DATE: <b>12/19/2017</b>	JOB NO. <b>1808</b>
ATTENTION: <b>Planning Department</b>	
RE: <b>Amended Site Plan Approval</b>	
<b>46 - 64 Maplewood Avenue</b>

## 46-64 MAPLEWOOD AVENUE

**RE: Application for Site Plan Review for 46 – 64 Maplewood Avenue, Portsmouth**

On behalf of 30 Maplewood, LLC, we hereby submit revised plans for the 46 - 64 Maplewood Avenue project for TAC approval. The plan set has been revised to address the comments from the October 31 Technical Advisory Committee meeting. The plans have been revised to reflect the following comments, with response in **bold** text:

**DEMOLITION PLAN** C2

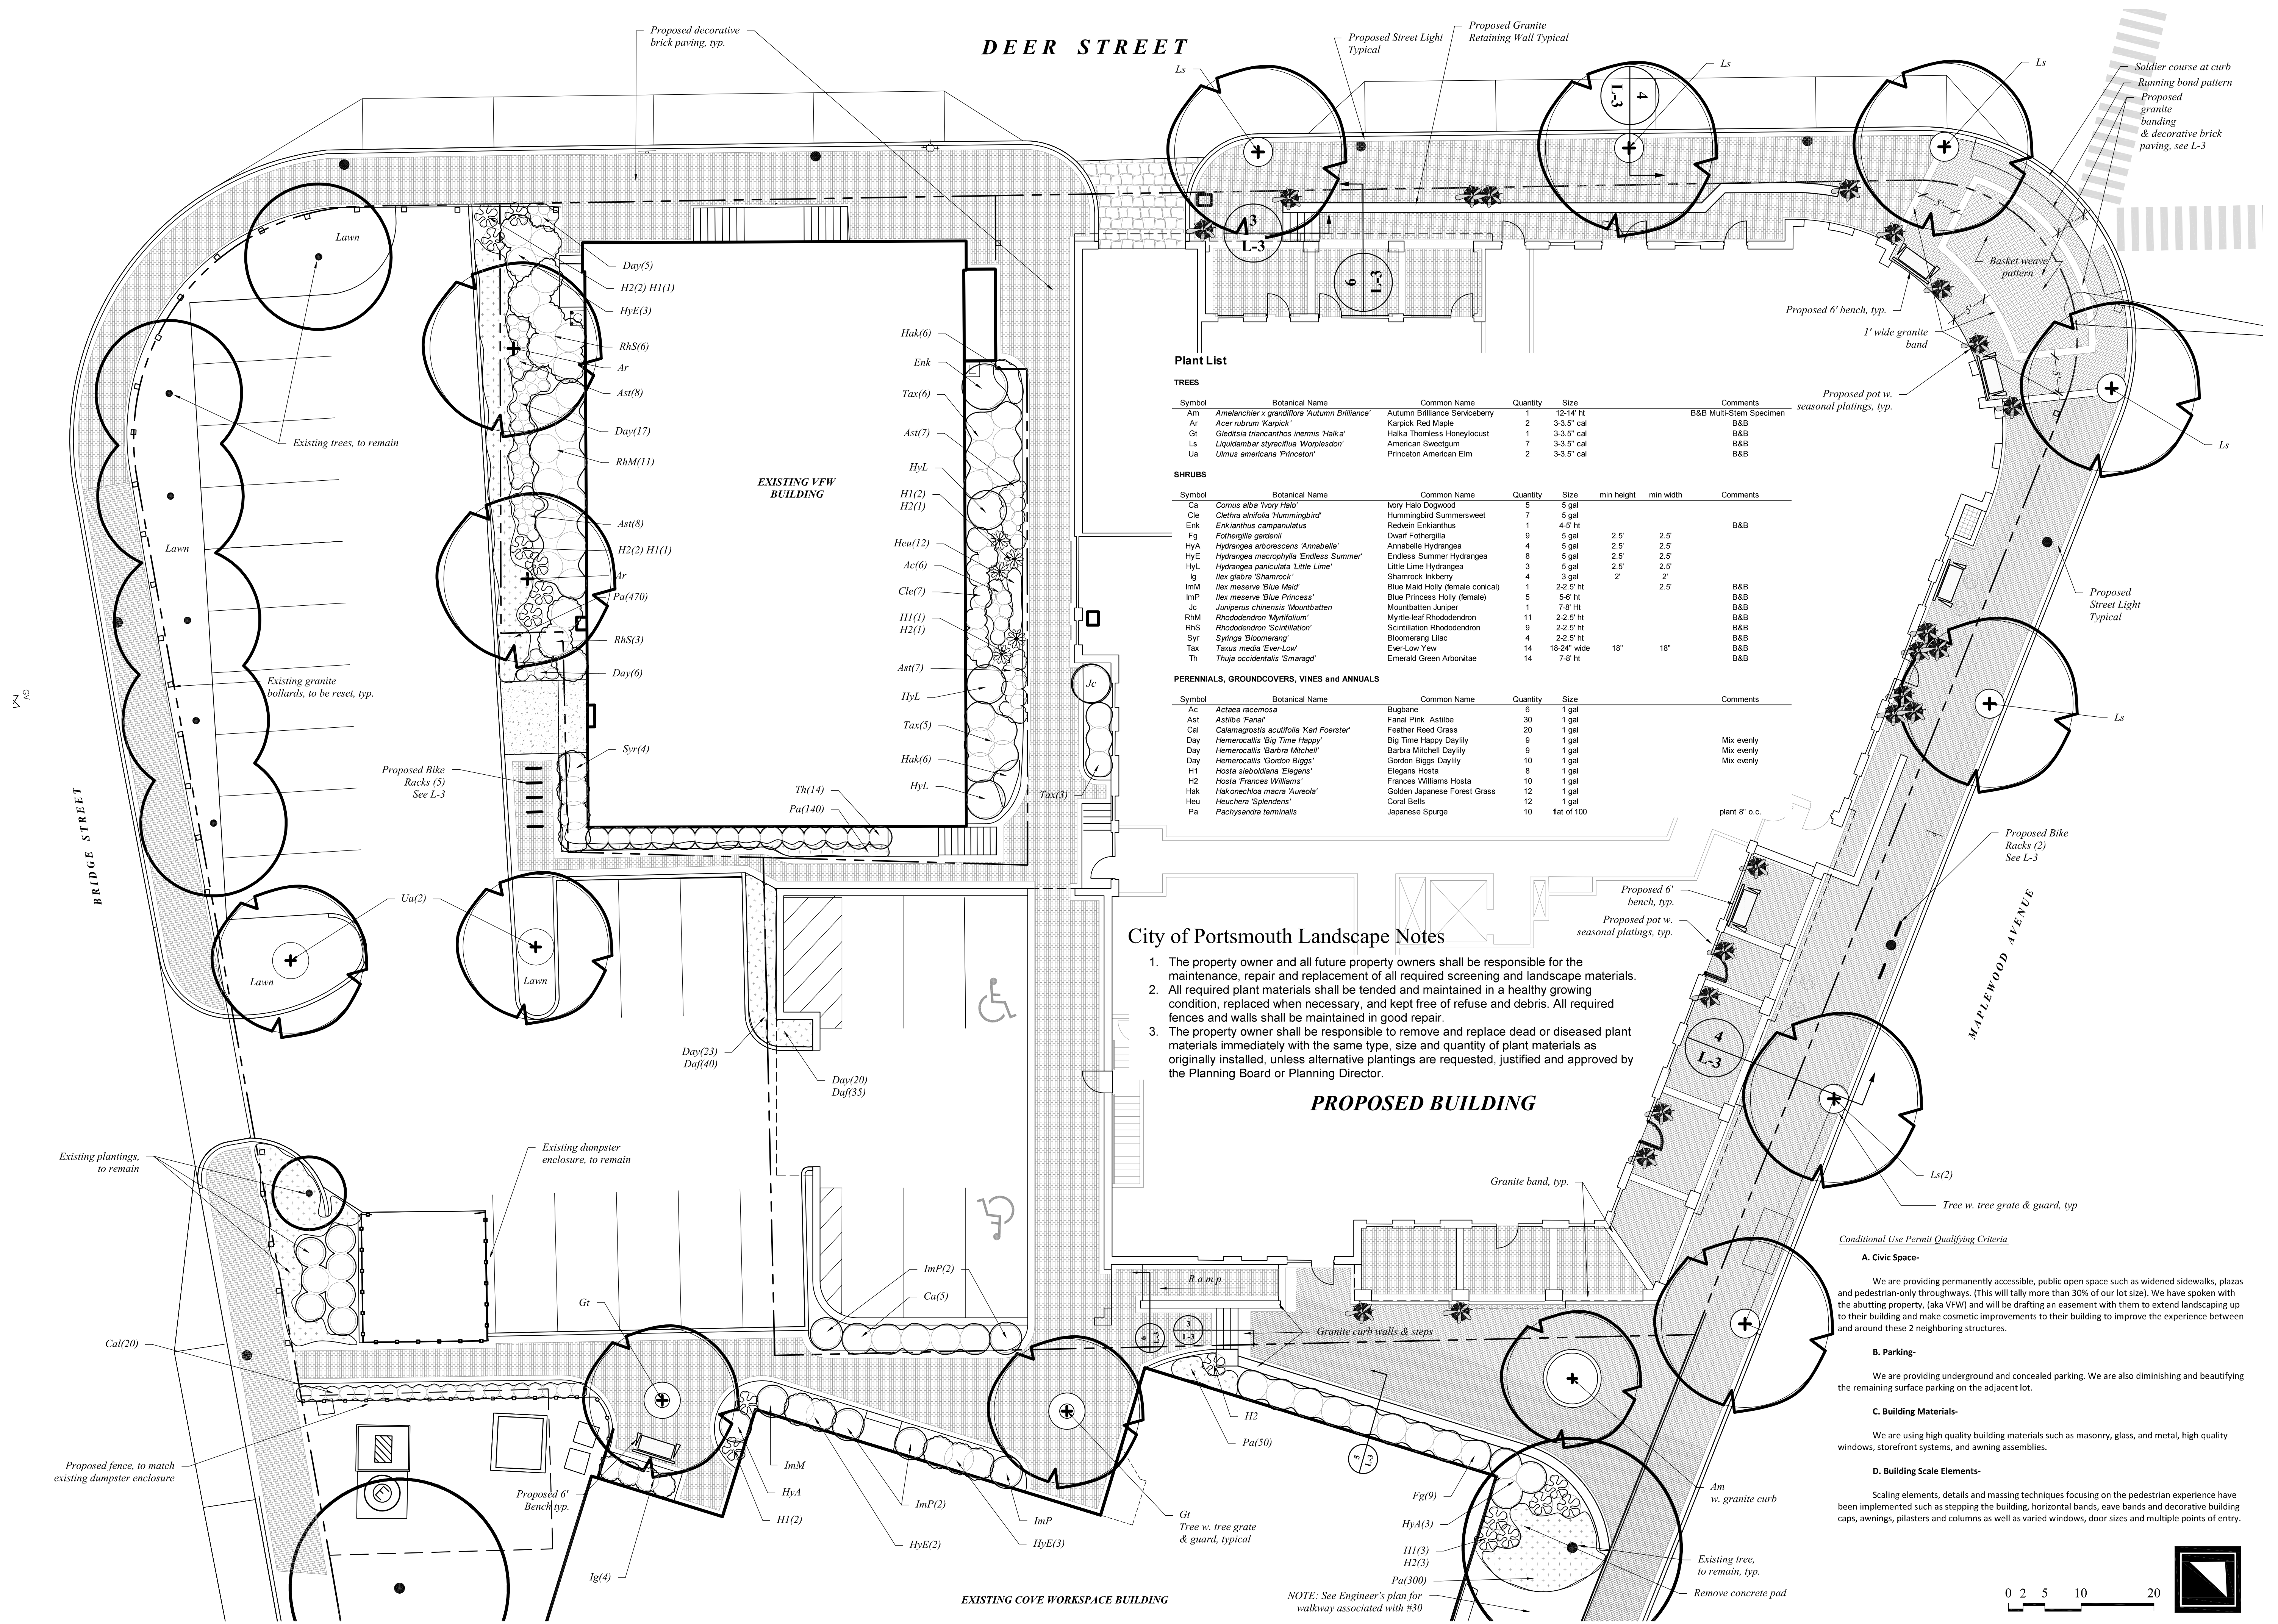
- The existing pipe to DMH 3543 is shown to be removed under the street. Instead, show it to be left in place and bulk-headed off. **This has been revised; See Sheet C2.**

**SITE PLAN**  
**FIRST FLOOR LEVEL**

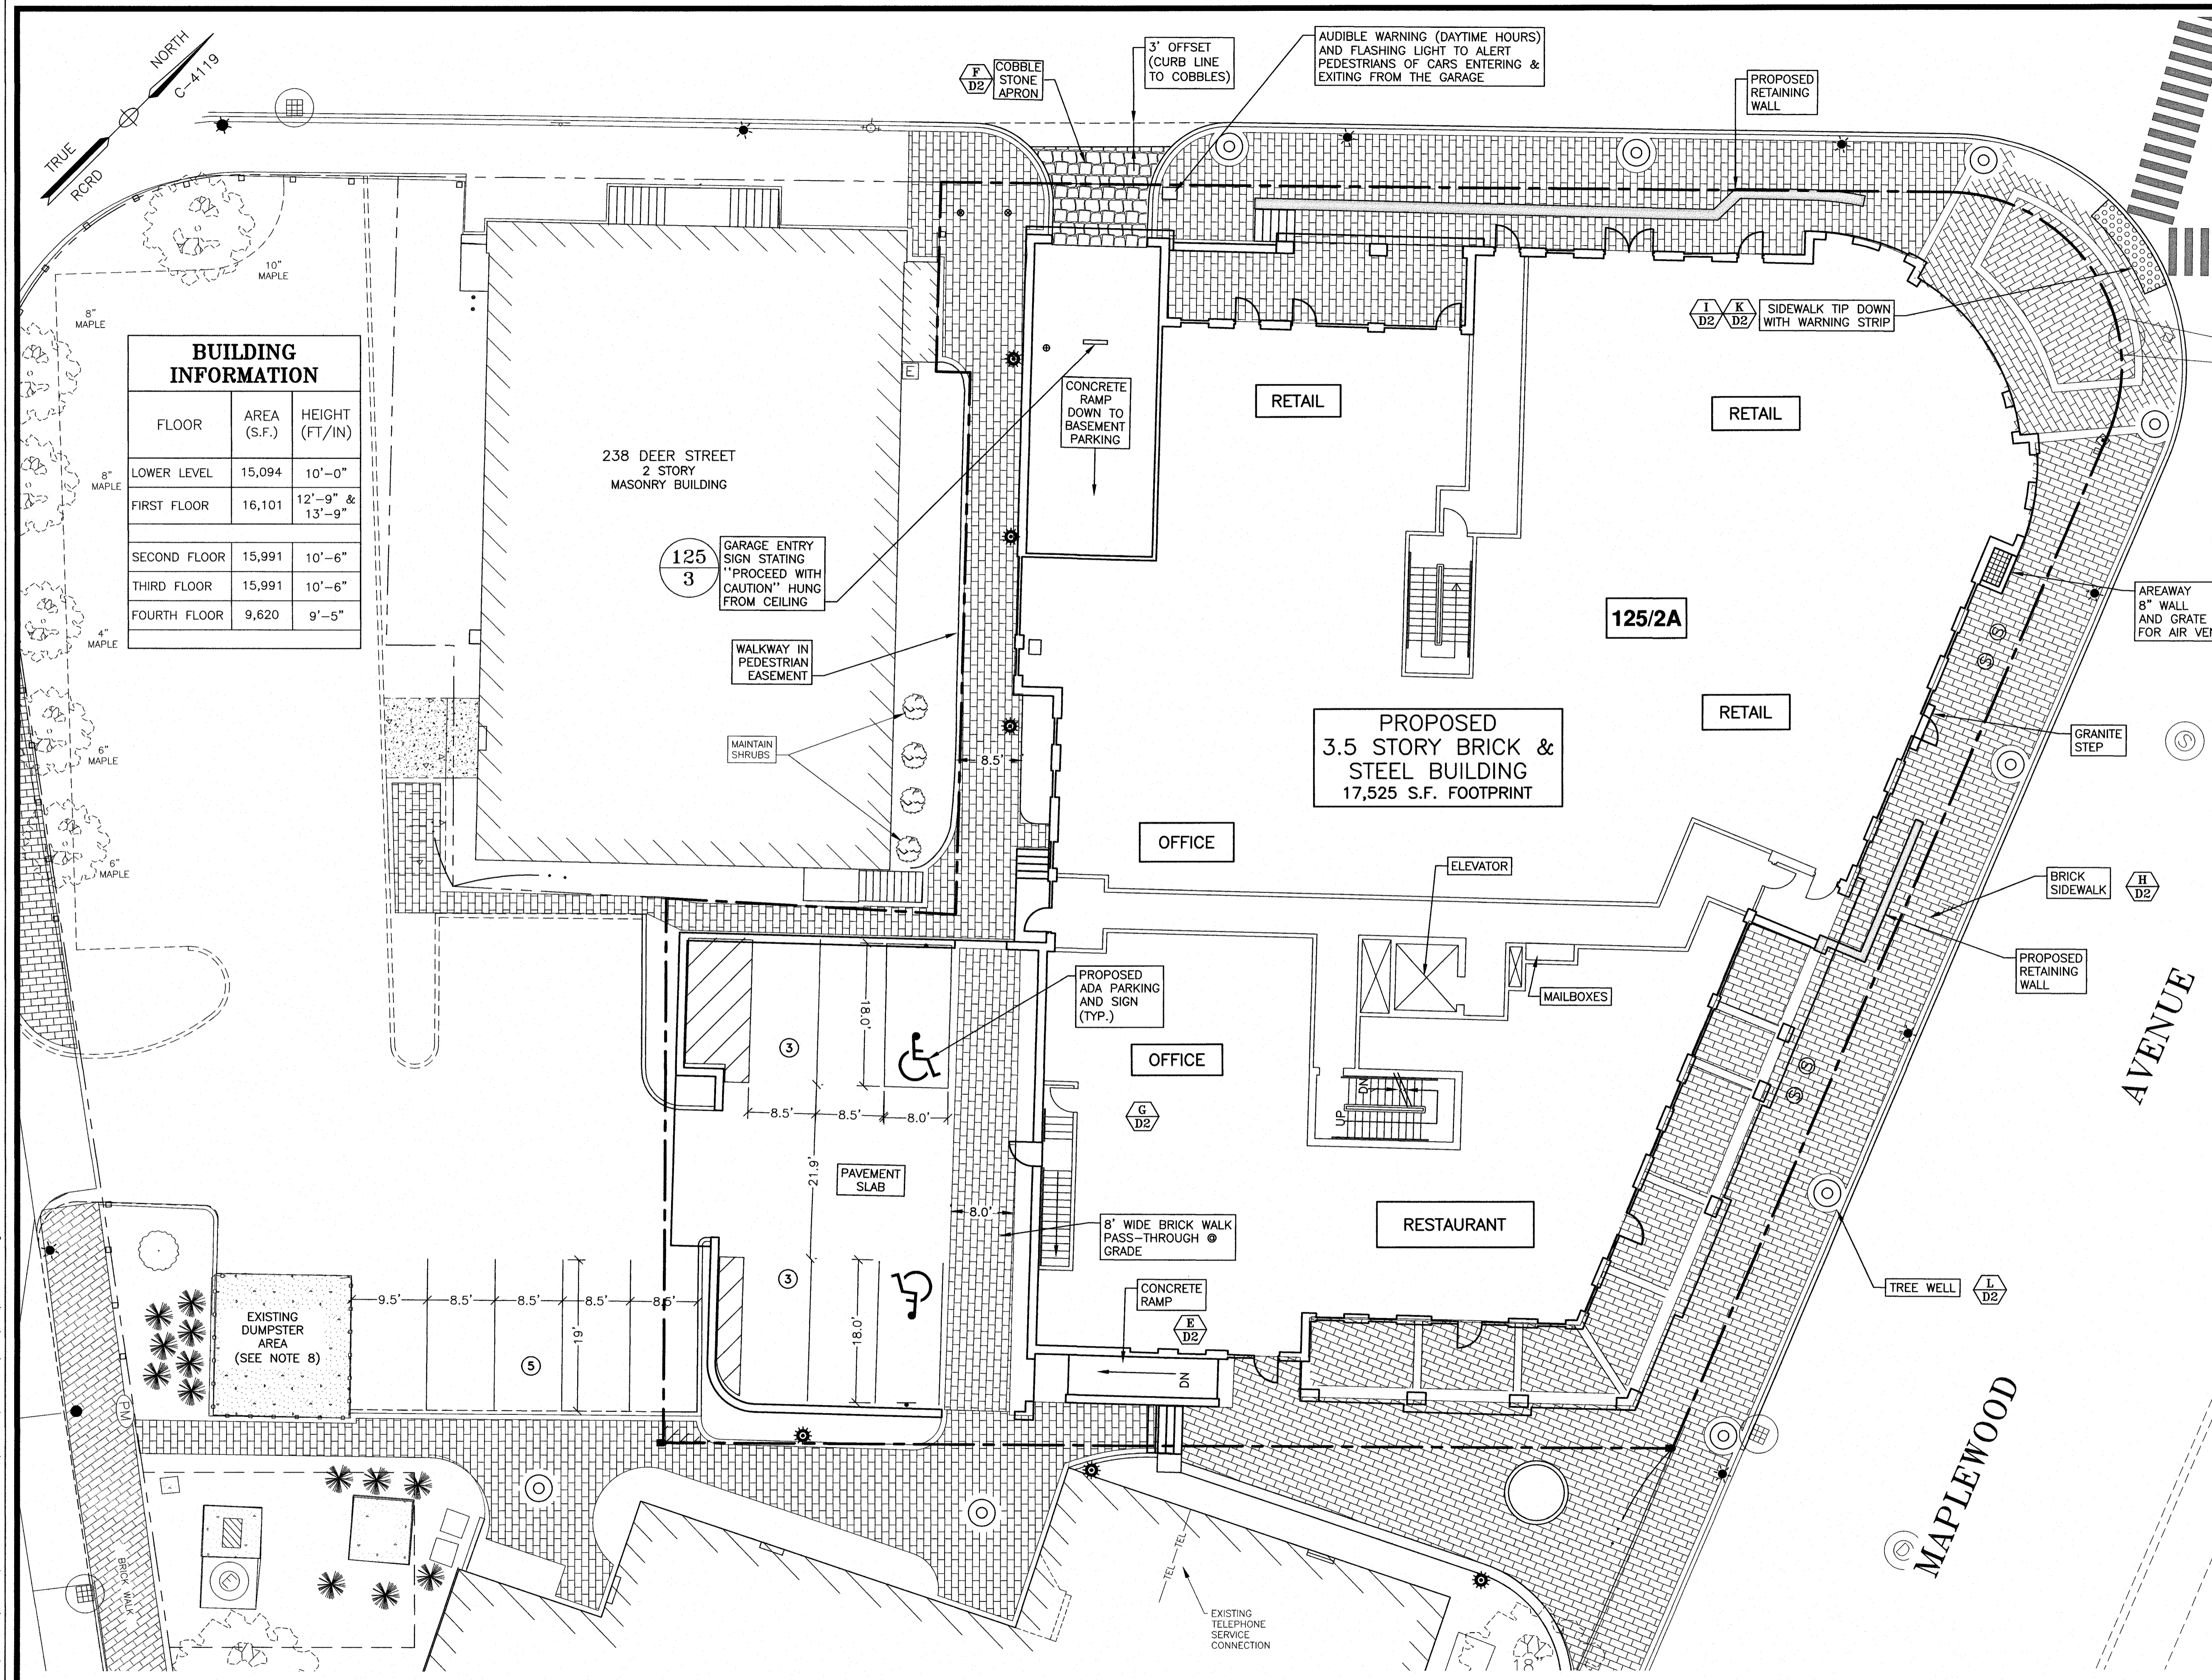
- We did not find the statement listing and describing “green” building components in the file. Please provide this. **Attached to this submission.**
- On sheet C3, please provide building dimensions (gross floor area, height), and floor area by floor. **This has been added to Sheet C3.**
